**Planning Department
Transportation Development Services**

Re: Car Crafters
5600 Holly Ave. NE
Traffic Circulation Layout
Engineer's/Architect's Stamp dated 3-24-15 (C18-D044)

CAR CRAFTERS
 SITE PLAN
 ALBUQUERQUE, NEW MEXICO
 PROJECT #1440

1 SITE PLAN
 1"=20'-0"

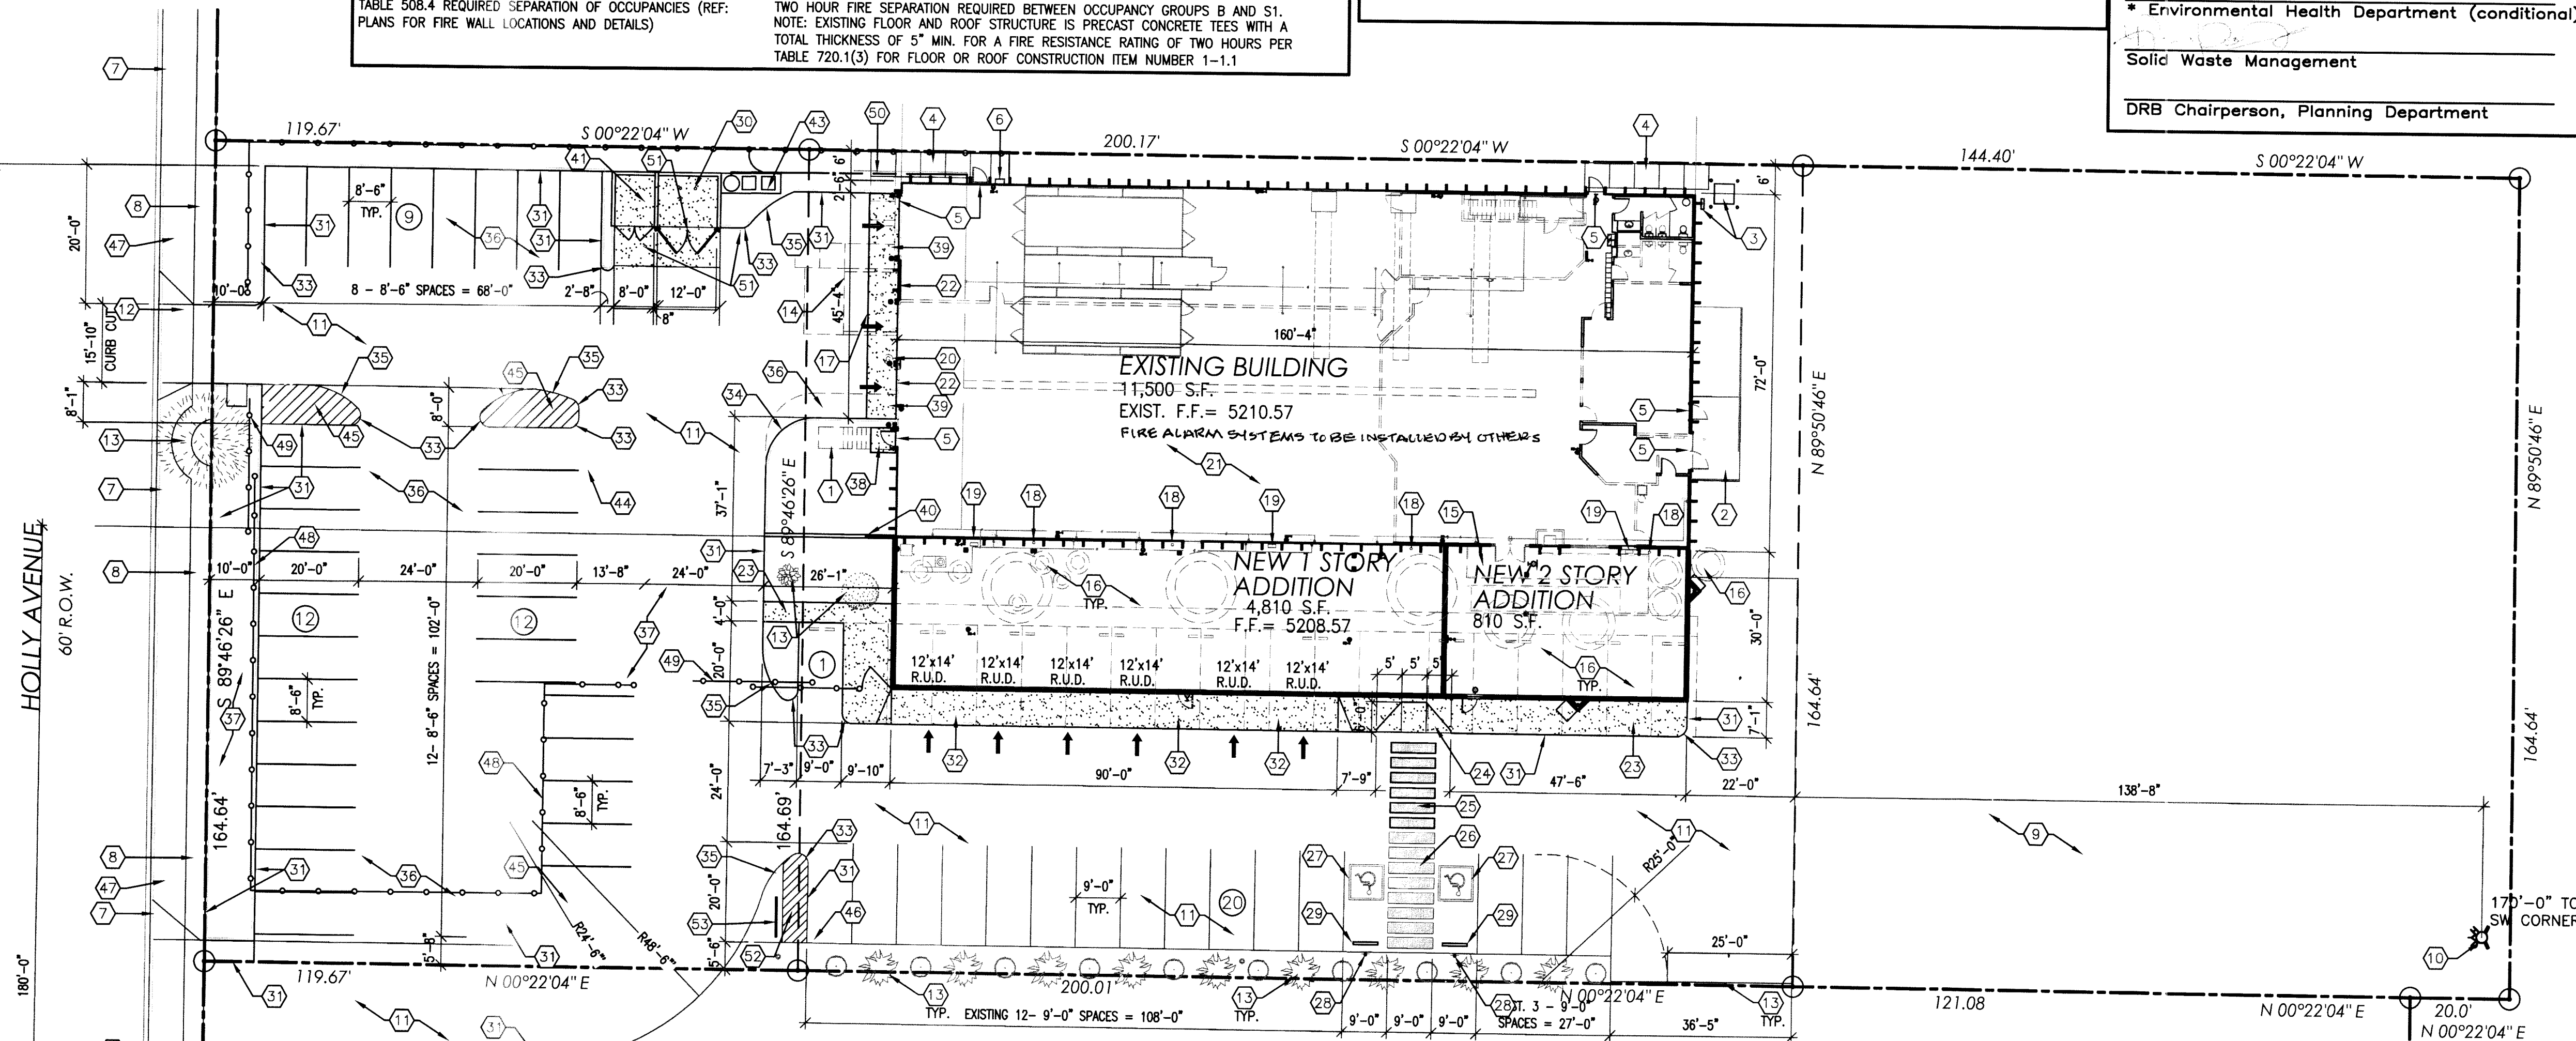
1. Please identify and dimension both exiting drive pads and ensure that they comply with the Clear Sight Triangle requirements. Ensure that the existing tree does not interfere with Clear Sight requirements.
2. Please provide a sight distance exhibit (see the *Development Process Manual*, Chapter 23, Section 3, Part D.5 Intersection Sight Distance).

3. Please add the following note to the clear sight triangle: "Landscaping and signage will not interfere with clear sight requirements. Therefore, signs, walls, trees, and shrubbery between 3 and 8 feet tall (as measured from the gutter pan) will not be acceptable in this area."
4. Please list the width and length for all parking spaces. The lengths of the parking spaces on the west side and north side are not dimensioned.

5. The ADA accessible sign must have the required language per 66-7-352.4C NMSA 1978 **"Violators Are Subject to a Fine and/or Towing."**
6. The ADA access aisle shall have the words **"NO PARKING"** in capital letters, each of which shall be at least one foot high and at least two inches wide, placed at the rear of the parking space so as to be close to where an adjacent vehicle's rear tire would be placed. (66-1-4.1.B NMSA 1978)

7. Show all drive aisle widths and radii.
8. Per the DPM, a 6 ft. wide ADA accessible pedestrian pathway is required from the public sidewalk to the building entrances. Please clearly show this pathway and provide details. The Site Drawing does not identify a pedestrian pathway from the public sidewalk.

9. Design delivery vehicle route needs to be shown or provided in an exhibit.
10. Please specify the City Standard Drawing Number when applicable.
11. Work within the public right of way requires a work order with DRC approved plans.

CAR CRAFTERS
SITE PLAN
ALBUQUERQUE, NEW MEXICO
PROJECT #1440

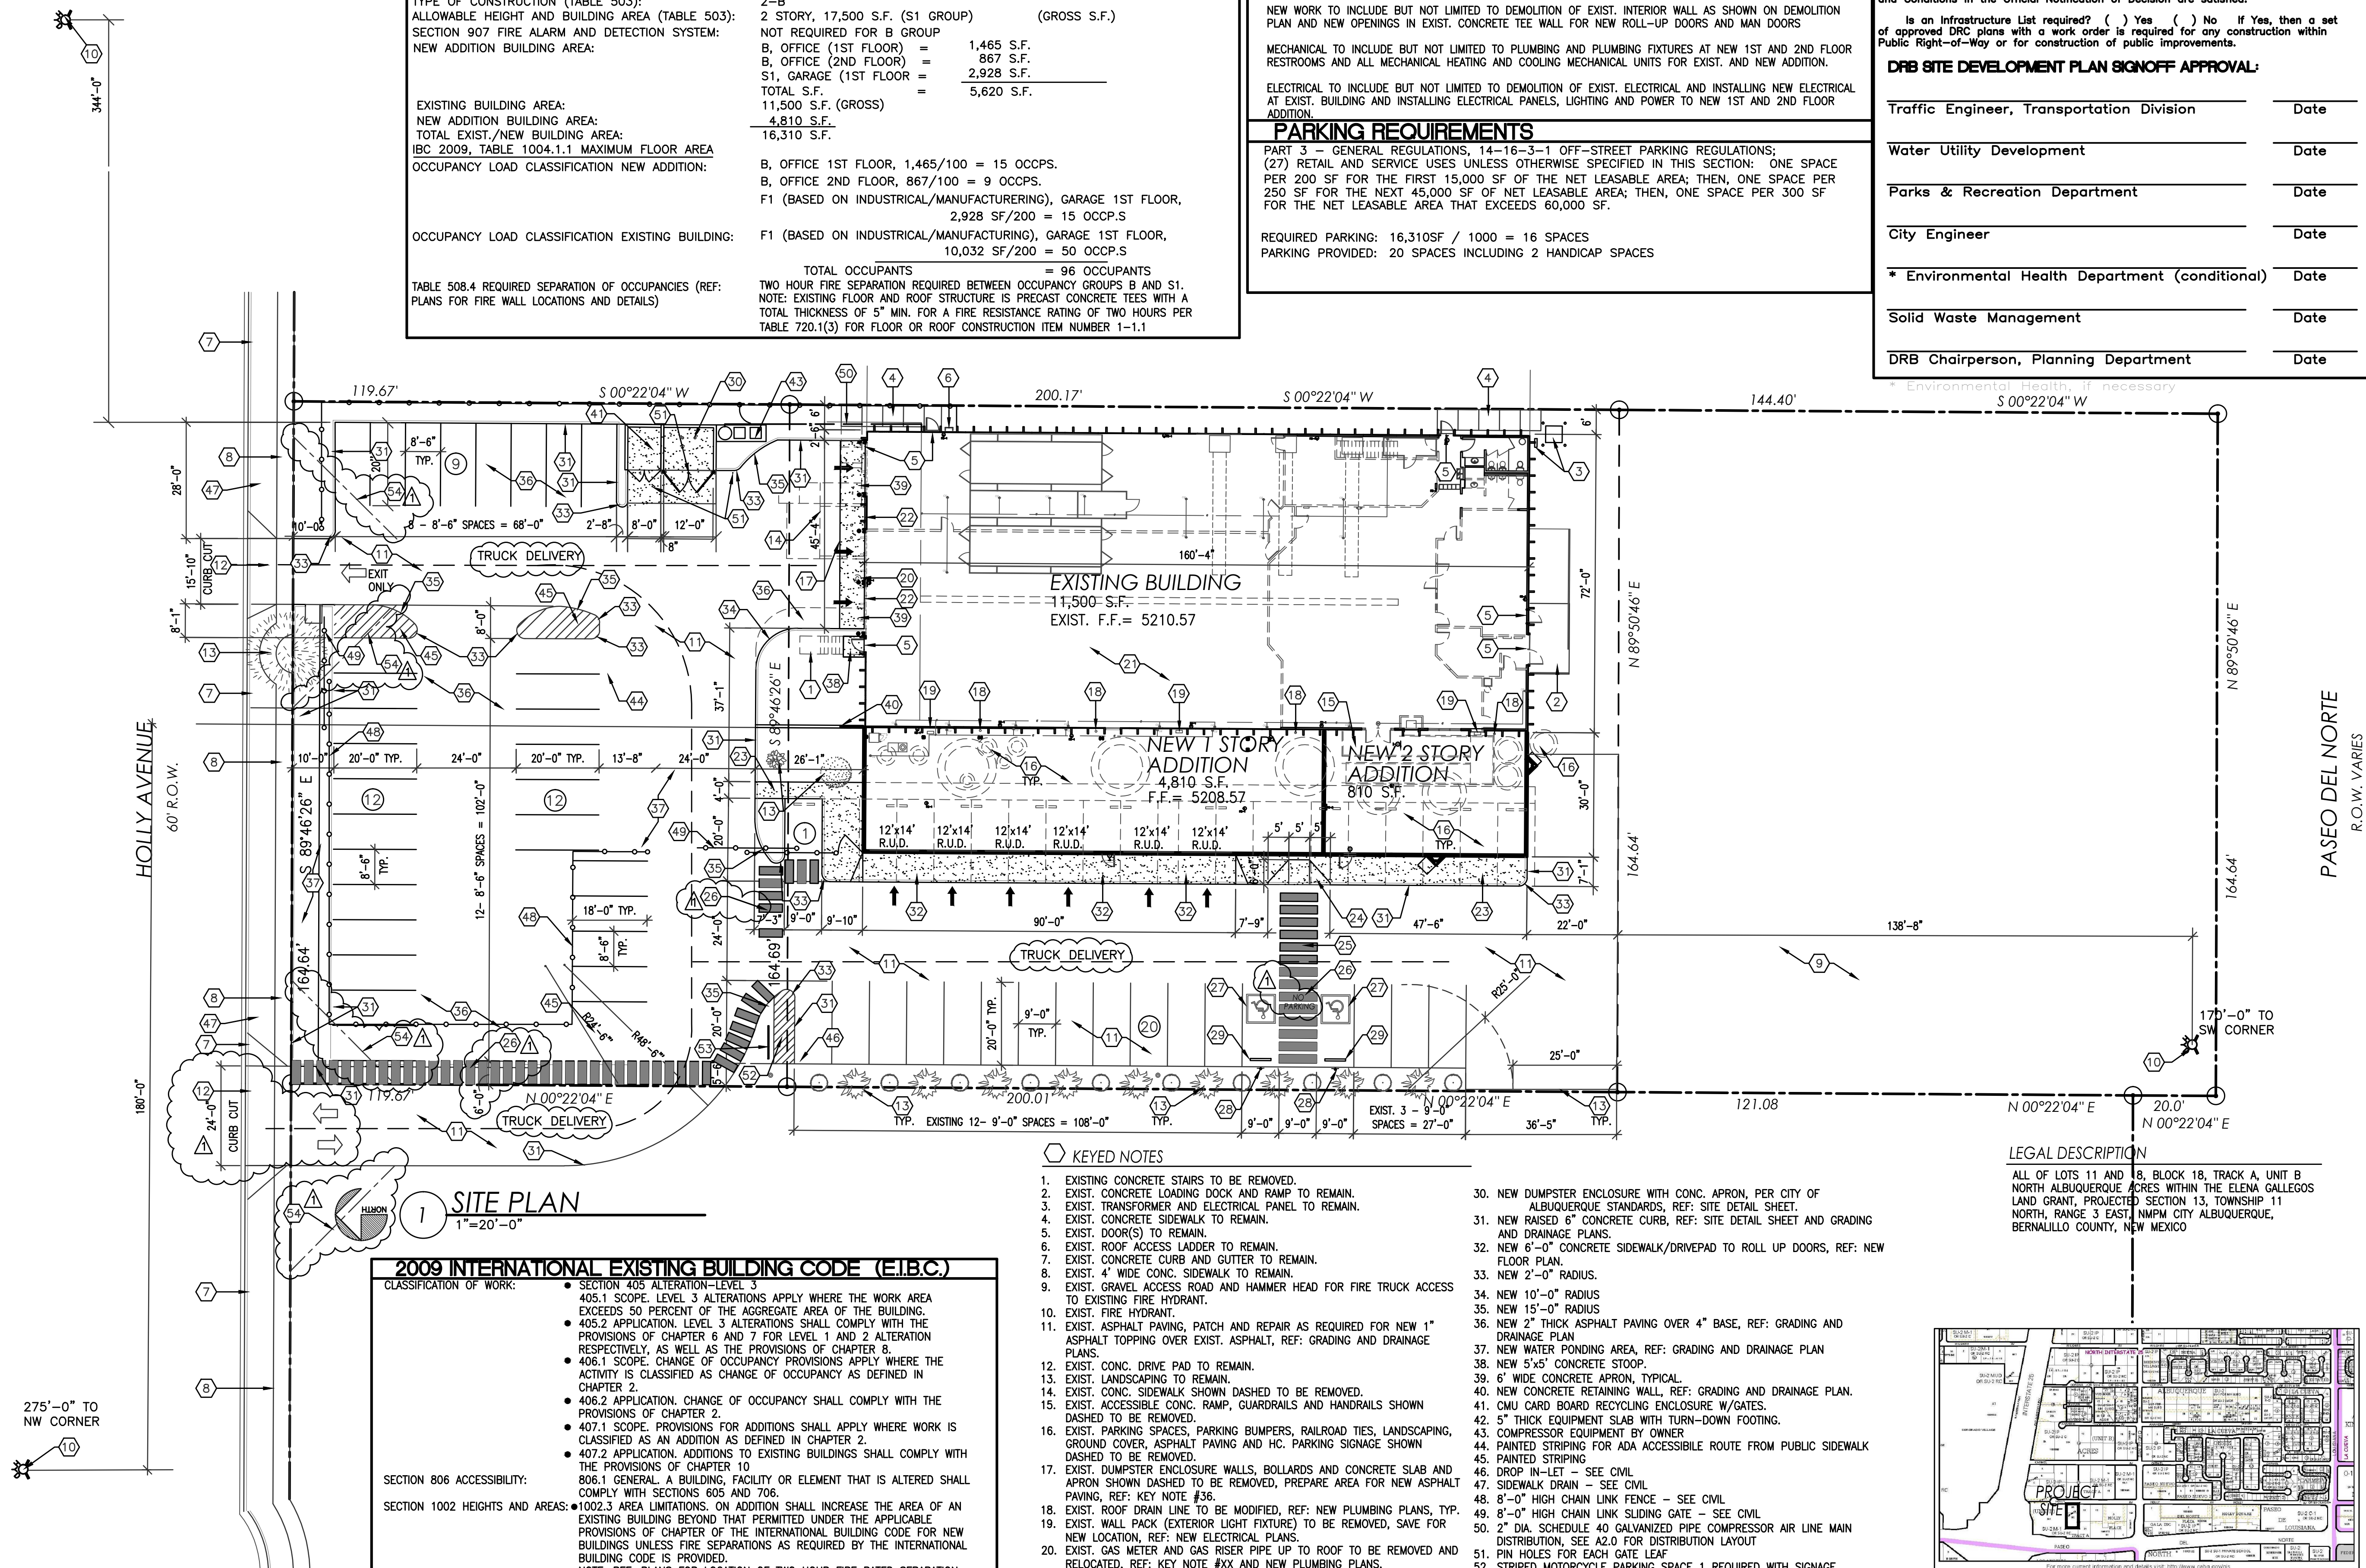
REVISION DATE
1 5/18/15 TRANSPORTATION
DEVELOPMENT COMMENTS
